Bid Title : Cross Creek Water Resource Facility and Rockfish Creek Water Resource Facility Screw Pump Improvements

Addendum Number: 2

ADDENDUM NO. 2 – TECHNICAL SPECIFICATIONS AND DRAWINGS

Cross Creek WRF and Rockfish Creek WRF Screw Pump Improvements

STRUCTURAL
CONCRETE REPAIR DETAILS AND NOTES - SHEET 2

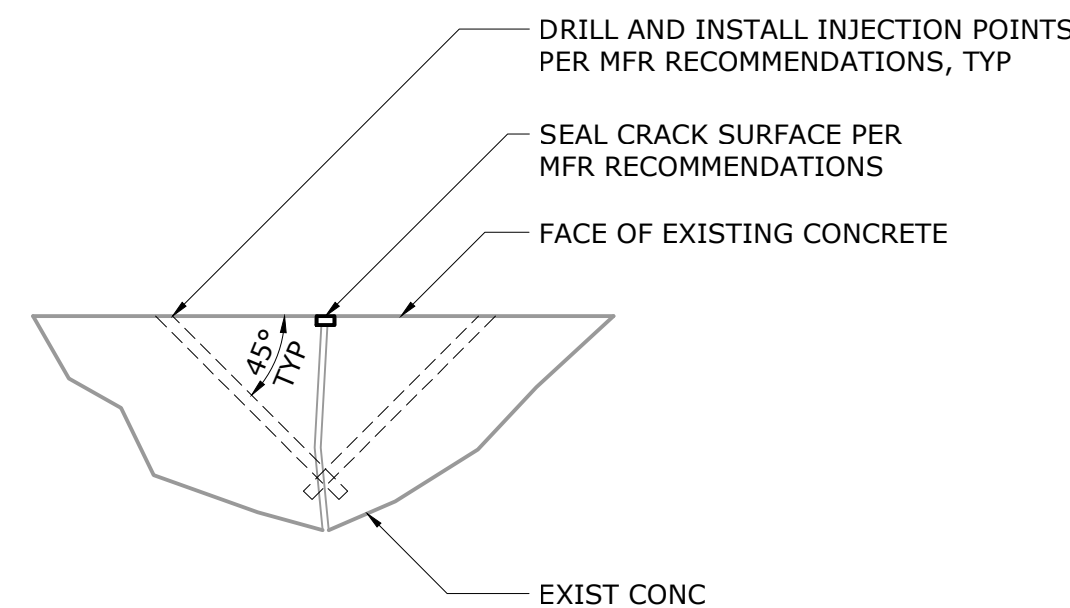
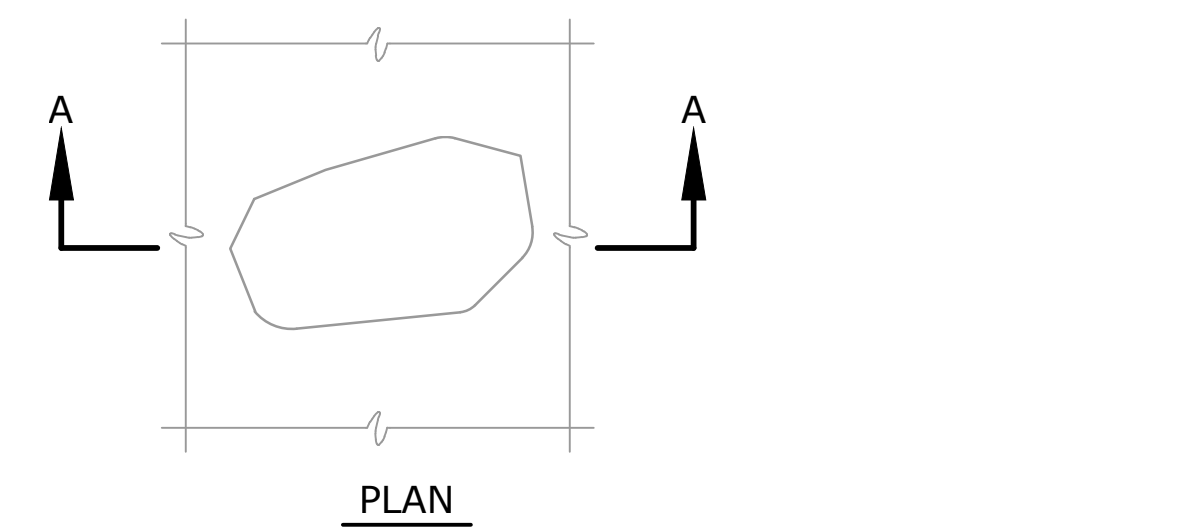
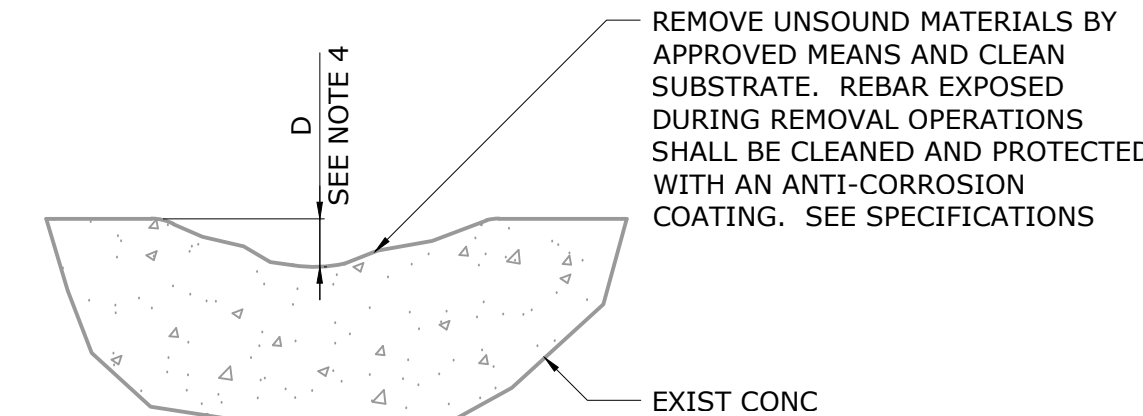
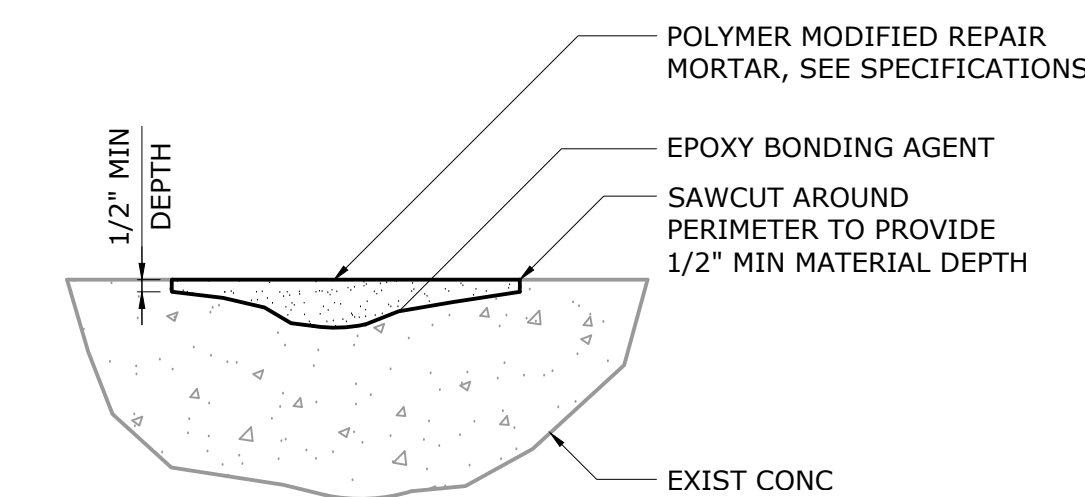
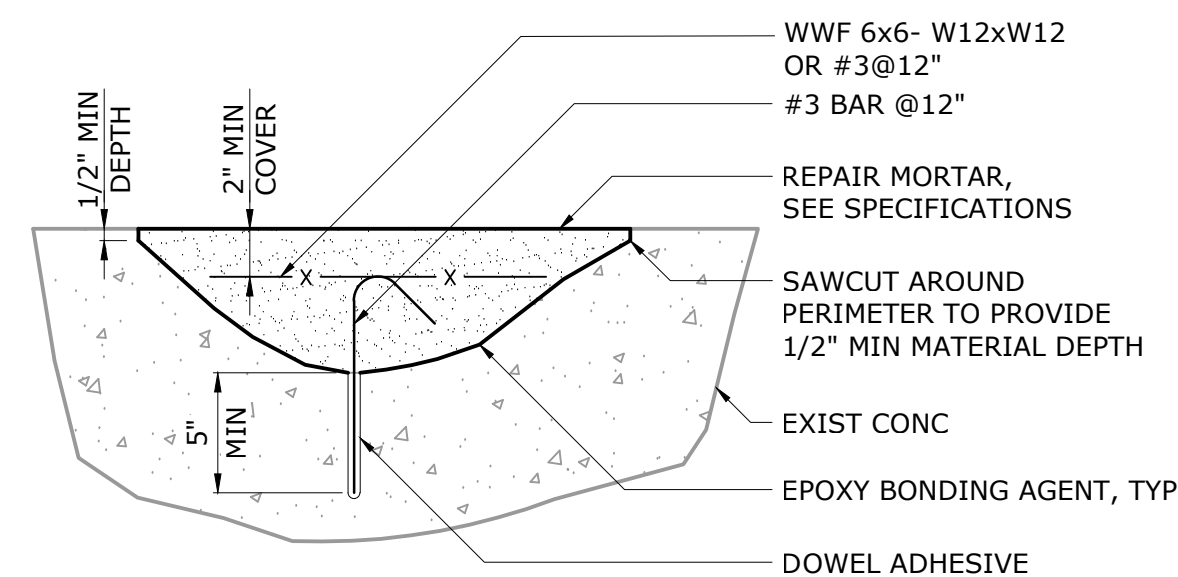
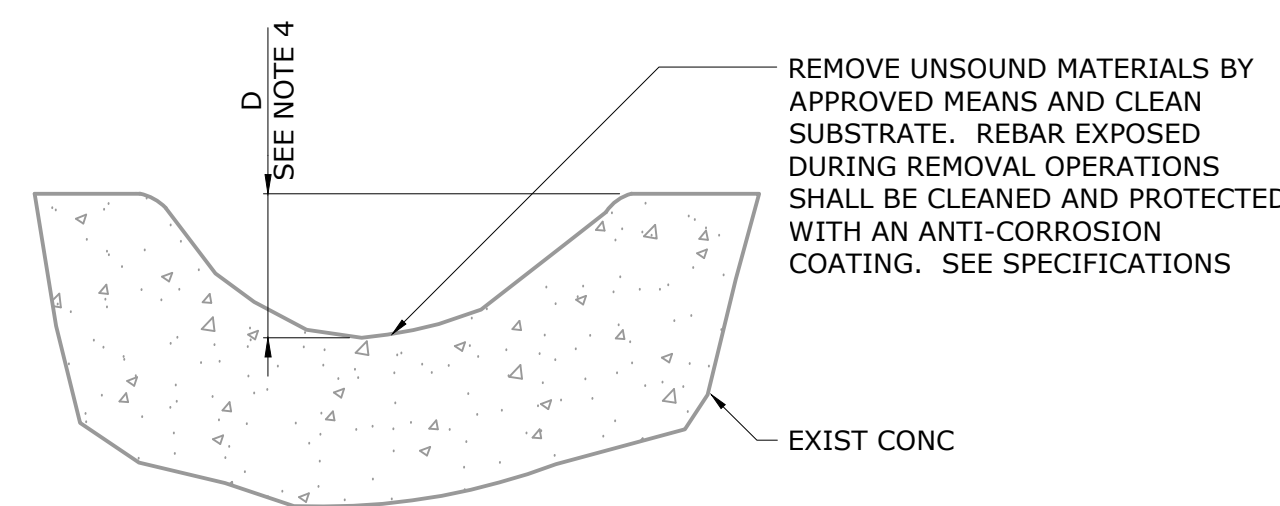
S2 Sheet S2 shall be issued as part of the Bidding documents. This sheet has been provided as **Attachment #1** of this Addendum.
